# Lowell Park

## Town of Barnstable ADA Transition Plan

September 2021

Institute for Human Centered Design

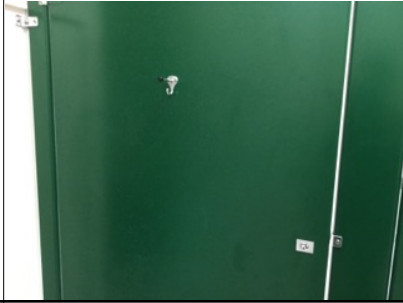
14	Men's Toilet Room	1		Doors, Doorways, & Gates	Toilet Room		Threshold > 1/2" high	1.75"	Alter the threshold to be 1/2" high max.	1	150	\$150
<b>Ramps</b>												
15	Bleachers Ramp (East Side)	Ext.		Ramps	Exterior		Running slope >1:12 (8.33%)	9.5%	Reduce running slope to be no steeper than 1:12 (8.33%). Provide a new 20' long ramp section at the middle area where the running slope is excessive.  (Cost based on 20' long new pressure treated wood straight ramp.)	1	4718	\$4718
